UNITED STATES PATENT AND TRADEMARK OFFICE

Office Action Summary

10/808,337

DETAILED ACTION

Figure 3 of Bruhn, Bruhn discloses suction ports 40 which are defined on an upstream side in the feed direction relative to a portion of the recesses:

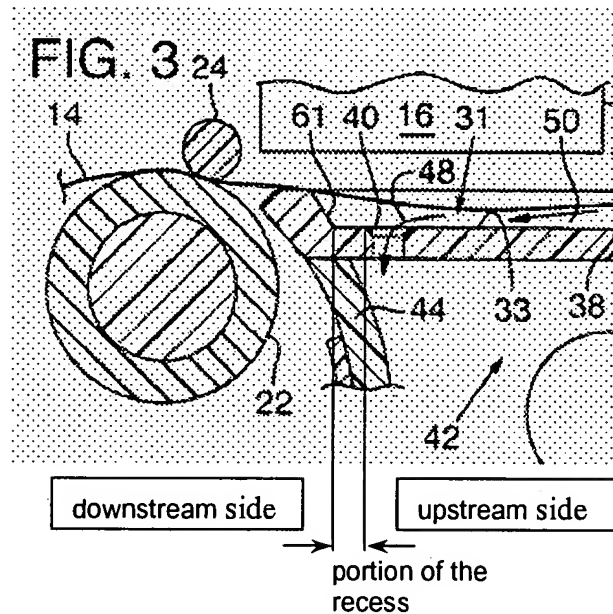
With respect to claim 38, Bruhn discloses an image forming apparatus including an image forming unit 16, a feeding device 22, a suction device 43, and a platen 12 including a plurality of paper receiving surfaces 52 which are provided on a surface of the platen 12 and extend in parallel with a predetermined direction as shown in Figure 1 of Bruhn. Also shown in Figure 1 are the surfaces 52 spaced at predetermined intervals; the intervals being spaced in a direction perpendicular to the predetermined direction. Bruhn further discloses recesses 31 which are defined between adjacent paper receiving surfaces 52 and extend in the predetermined direction and escape portions 61 which are provided on a downstream side of a portion of the recesses 31 and maintain the printing medium and the recess in a separated manner. As shown below, in the Figure taken from

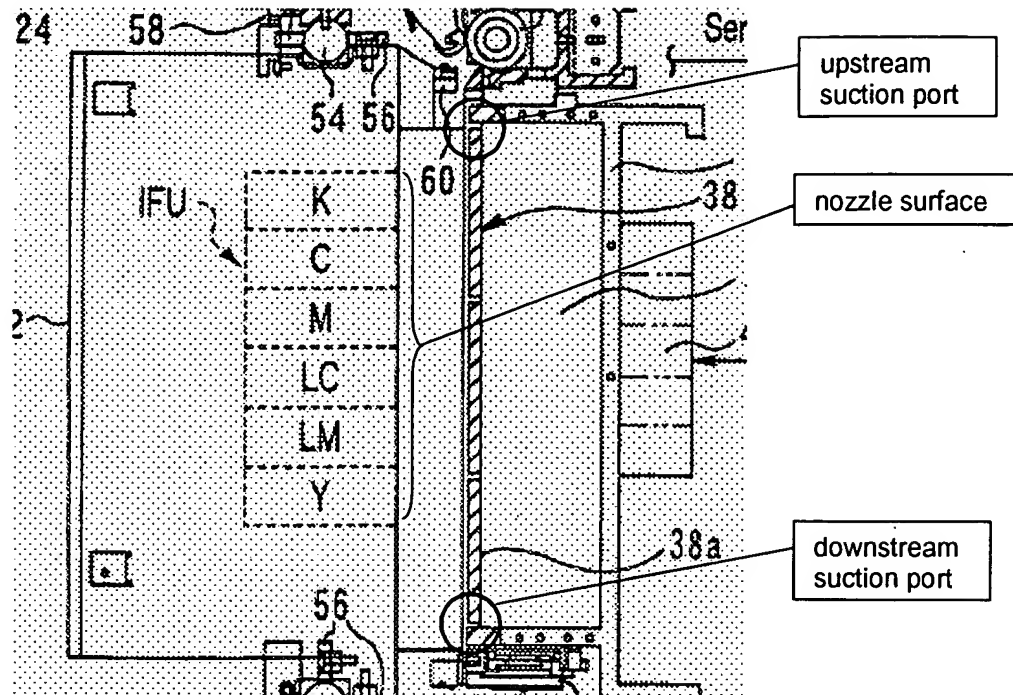
With respect to claim 8, Miki et al. teaches an upstream suction port that is provided in region of the platen outside a region where the platen faces a nozzle surface as shown below in the Figure taken from Figure 1 of Miki et al.:

With respect to claim 32, Miki et al. teaches an upstream suction port that is provided in region of the platen outside a region where the platen faces a nozzle surface as shown in the above Figure taken from Figure 1 of Miki et al.
